Access Compliance Report

Public Rights-of-Way

Intersection ID: 10034489	Main Street: PINEBURR_RD	Cross Street: N/A	Location: NW
ADA ID: 5E9A0B9812A4	Ramp Type: BlendTrans2	Initial Pass/Fail: Fail	Overall Compliance: No
		Severity Score: 12.5

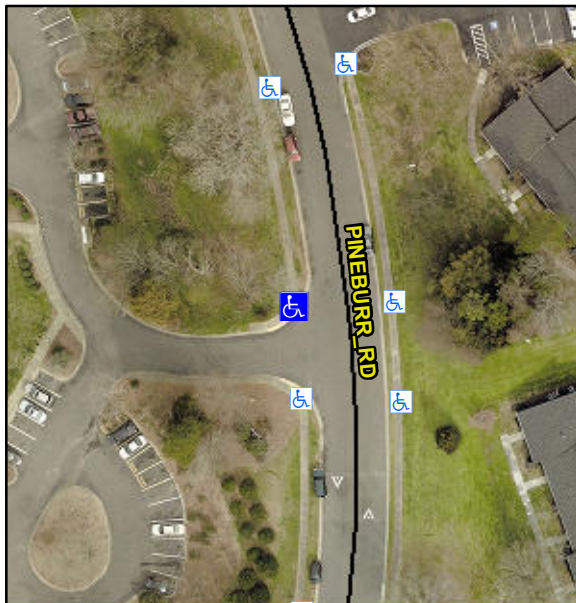
Not Found, R304.5.3

Compliance	Description	Data	Compliance	Description	Data
N/A	Ramp Length (in)	57.0	Yes	BlendTrans Slope (%)	1.6
Yes	Ramp Width (in)	48.0	No	BlendTrans XSlope (%)	5.2
N/A	Flare Type LT	N/A	N/A	Flare Type RT	N/A
N/A	Flare Slope LT (%)	N/A	N/A	Flare Slope RT (%)	N/A
N/A	Flare Traversable LT?	N/A	N/A	Flare Traversable RT?	N/A
N/A	Landing Length (in)	N/A	N/A	DWS Provided?	N/A
N/A	Landing Width (in)	N/A	N/A	DWS Contrast?	N/A
N/A	Landing Slope (%)	N/A	N/A	DWS Length (in)	N/A
N/A	Landing X Slope (%)	N/A	N/A	DWS Full Width?	N/A
N/A	Landing Curb? (Y/N)	N/A	N/A	DWS Offset (in)	N/A
N/A	Shared Landing?	N/A			
N/A	Gutter Ponding?	N/A	N/A	Gutter Slope (%)	N/A
N/A	Gutter Lip Ht (in)	N/A	N/A	Gutter X Slope (%)	N/A
N/A	Painted X Walk1?	No	N/A	Painted X Walk2?	No
	X Walk 1 Direction	To S		X Walk 2 Direction	To E
	X Walk 1 Width (in)	N/A		X Walk 2 Width (in)	N/A
	X Walk 1 Slope (%)	4.7		X Walk 2 Slope (%)	1.2
	X Walk 1 X Slope (%)	6.5		X Walk 2 X Slope (%)	0.0

N/A	Ramp inside XWalk1?	N/A	N/A	Ramp inside XWalk2?	N/A
	Road Slope (%)	3.7		Clear Space?	N/A
	Road X Slope (%)	1.0	N/A	Clear Space to XWalk (in)	N/A
N/A	Any Obstructions?	N/A	N/A	Storm Grate/Utility Hazard?	N/A
	Obstruction Type			Storm Grate/Utility Type	
		N/A			N/A
			Yes	Surface Condition? (G/P)	Good
			No	Curb Slope (%)	14.0

Remove & Replace Curb Ramp With Two New Directional Ramps or Equivalent.
